**Town of Rotterdam
Planning Commission
July 19, 2022**

DPW Comments
July 19, 2022

To: Peter Comenzo, Senior Planner – Town of Rotterdam
From: Daniel Farnan, PE, CPESC, CPSWQ
Date: July 15, 2022
Subject: Rotterdam Wellness, - TM# 47.-8-1.2 –Submittal Review - Final
Project No.: CED: 21002349G - 004

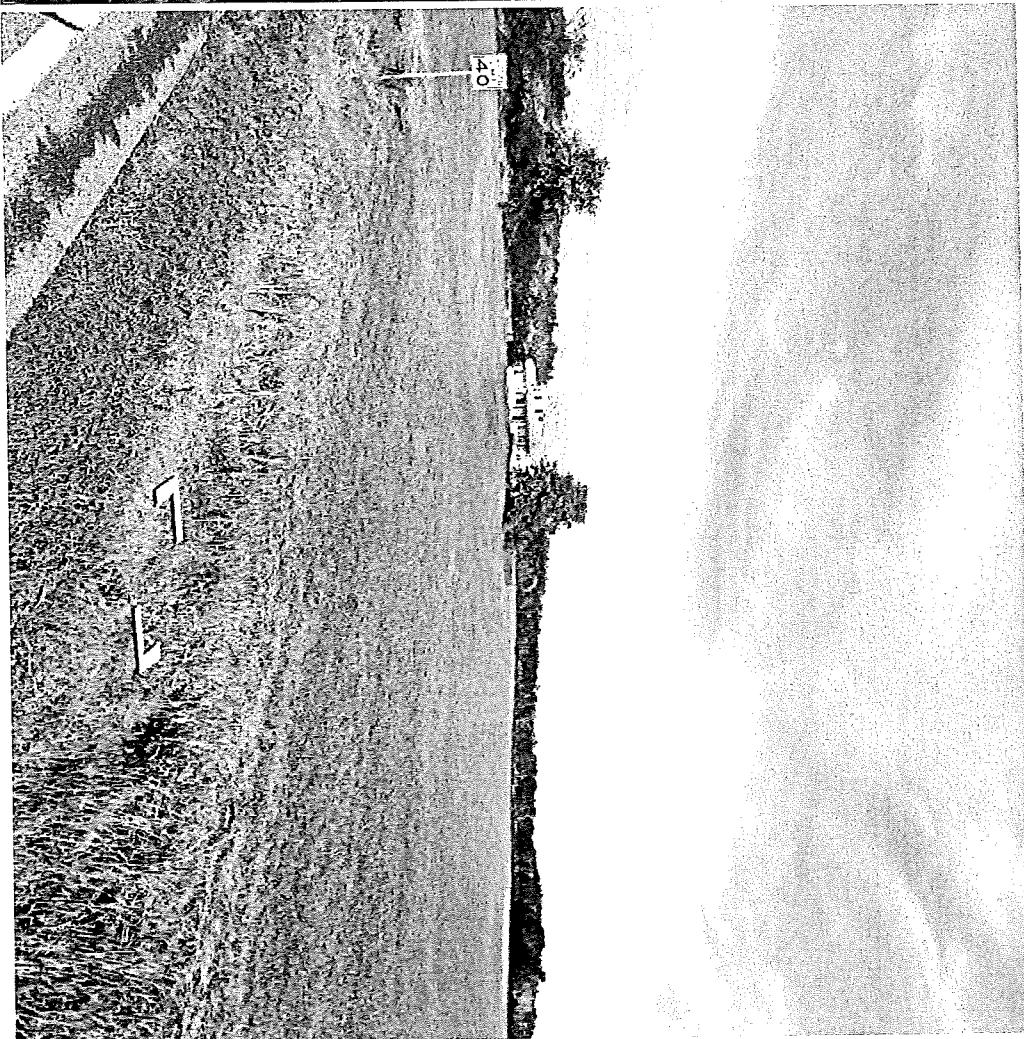
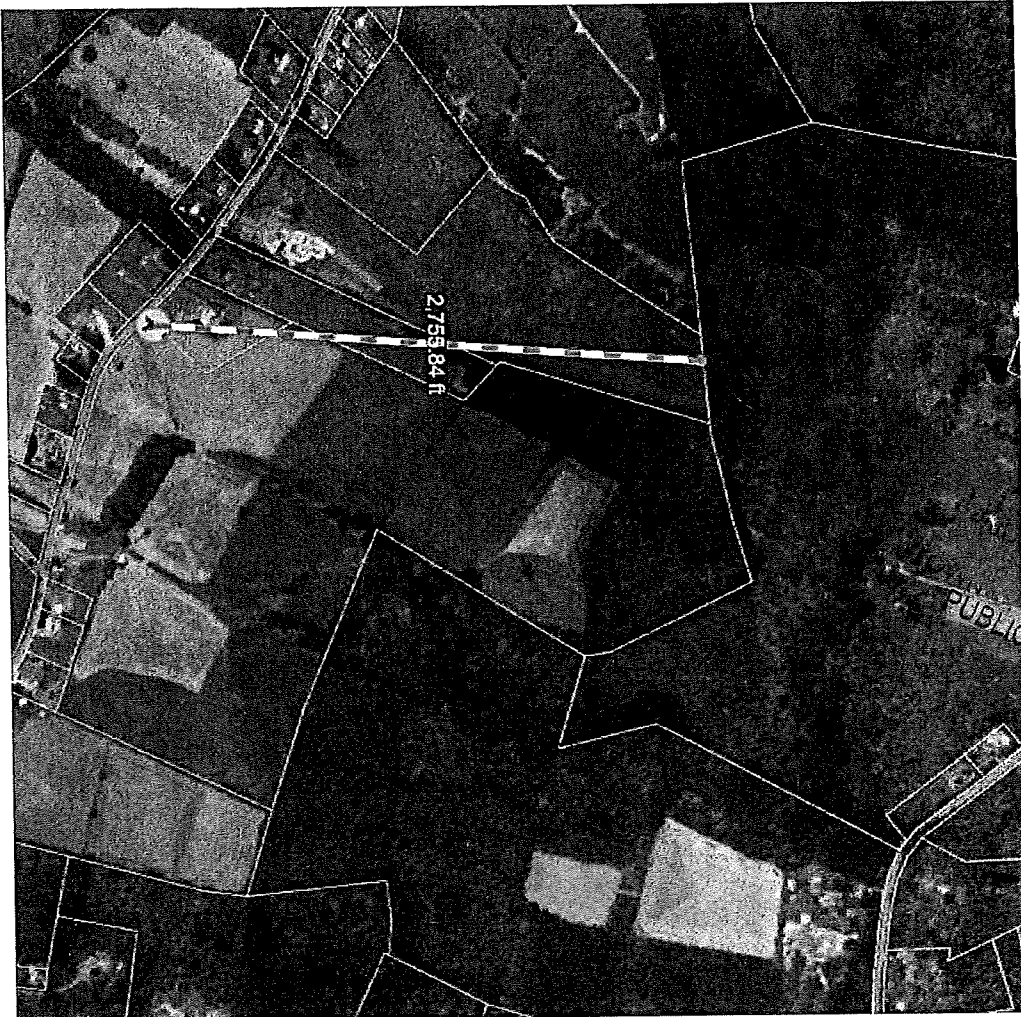
- b. *Please update all application documents where snow plowing is mentioned with the resolution to this item.*

The attached proposed project Operations & Maintenance (O&M) Plan indicates that snow removal from the access drive will be required to allow site access during winter months when snow accumulation is greater than 10" in any one snowfall event, however no snow removal operations will be performed within the array areas. Snow removal may also be performed if emergency inspection / repairs are needed.

It should be noted that the proposed access drive is entirely privately owned and therefore would not be under Town DPW jurisdiction or maintenance. The Applicant has been in communication with the Fire Department regarding emergency access, including snow removal, and no exception has been taken to the project as currently proposed. Documentation from the Fire Department will be provided upon its availability.
